**Comments of the Kalispel Tribe of Indians  
on the  
LeClerc Creek Grazing Allotment Management Planning  
Draft Environmental Impact Statement**

The LeClerc Creek Grazing Allotment Draft Environmental Impact Statement (“DEIS”) does a disservice to our community by failing to present an alternative that would satisfy the interests of both the Kalispel Tribe of Indians (“Tribe”) and the permittee. Without such an alternative, the DEIS pits neighbor against neighbor and beckons the rest of the community to choose sides. That is an unfortunate outcome in a small community such as ours, particularly when a more nuanced solution could have been developed with a modicum of federal will.

### 7-day average of the daily maximum temperatures recorded during July 15th – August 15th within the upper (EBL3) and lower (EBL1) East Branch LeClerc Creek

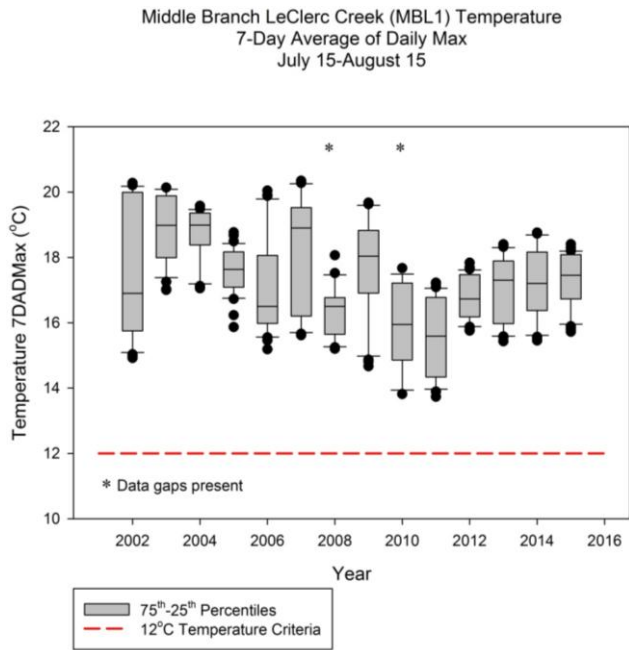
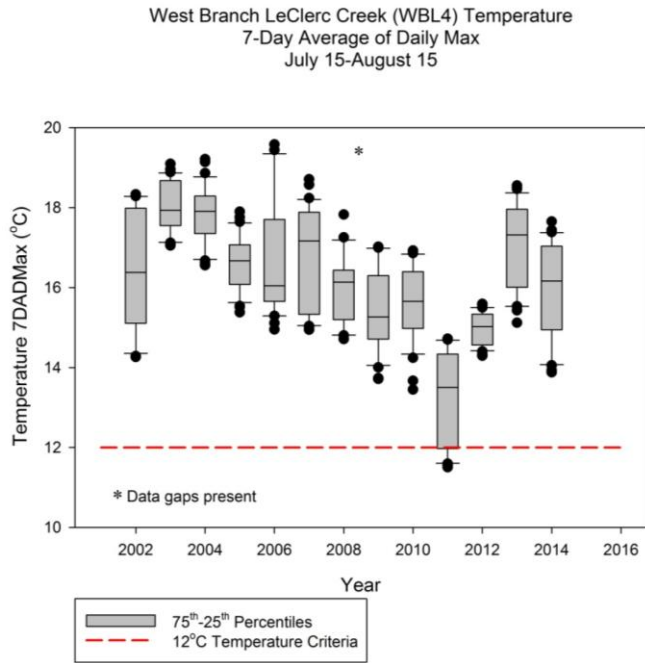
1. Kalispel Natural Resources Department (“KNRD”) monitoring of LeClerc Creek Basin tributaries shows consistent summer exceedance of the WA Char spawning and rearing numeric criterion of 12°C (see below). This results in the default narrative criterion of no significant human-caused change from natural conditions being in effect.

- The DEIS continues to use the wrong temperature standard for the LeClerc watershed. The correct temperature criterion is 12°C under Washington State water quality standards and less than 9°C under InFish.<sup>38</sup> Compliance with these standards requires retention of all available shade.

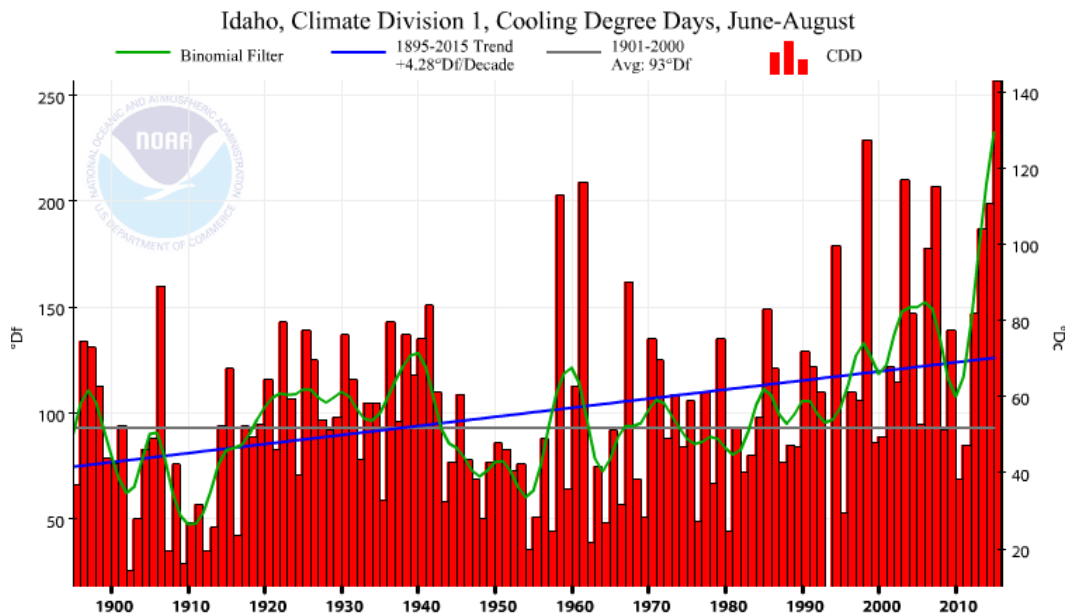
2. The Colville National Forest (“CNF”) and WA Ecology assumption that implementation of INFISH with continued riparian grazing in the LeClerc Basin will achieve compliance with the Char temp criteria over the next 30-40 years is wrong. It will be necessary to achieve the maximum riparian shade potential throughout the Basin to restore the water temperature to natural conditions under existing climatic conditions. Continued climate warming will also require implementation of other actions to further cool streams such as restoring and enhancing cold hyporheic flow.

All riparian corridor management actions available to maximize riparian shade recovery will need to be implemented considering the well-understood impacts on the riparian zone by cattle grazing which contribute to changes in hydrology, destabilizing of stream banks, sedimentation, and changing or eliminating of riparian vegetation (Kauffman and Krueger, 1984). The loss of riparian shade and changes in stream morphology commonly contribute to increased water temperature along with other ecological effects (Platts, 1979) and is also well-explained in the DEIS.

- c. Grazing exclusions must be implemented beginning now throughout all of the riparian corridors of the LeClerc Basin along with shade tree restoration to the assure full recovery of the maximum shade potential necessary to eliminate existing and future contribution of man-caused stream warming. This is especially critical in the face of projected climate change discussed above.

The background plot shows simulated Northwest temperature (see Mote et al. 2013) from 20 global climate models for two different scenarios of future emissions, which have been smoothed to emphasize slow variations. Darker lines show the multi-model mean for each RCP

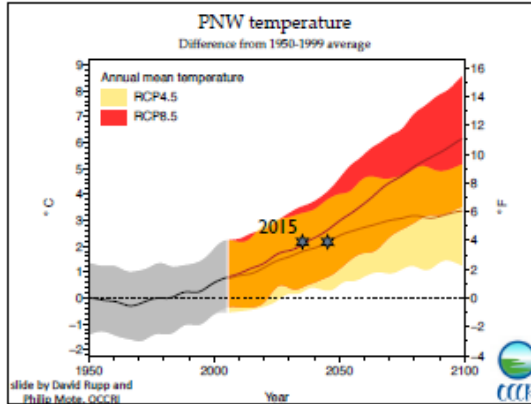
- b. Predictions for atmospheric warming in the PNW suggest that average temperature experienced in 2015 will be the normal condition around the years 2035-40 with the anticipated rate of continued increase in global CO<sub>2</sub> emissions (see below). Atmospheric warming has reportedly contributed to waterbodies warming in North America at an average rate of around 0.2°C/decade over the last 30-40 years (Rice and Jastram, 2014; Isaak *et al.*, 2011).

According to NOAA's Climate at a Glance utility, the Water Year 2015 (i.e., Oct 2014 through Sept 2015) temperature in the Northwest was +3.9°F above the 1950-2000 average. This is indicated by the stars, where they intersect the future curves for RCP8.5 (in about 2033) and RCP4.5 (in about 2045).
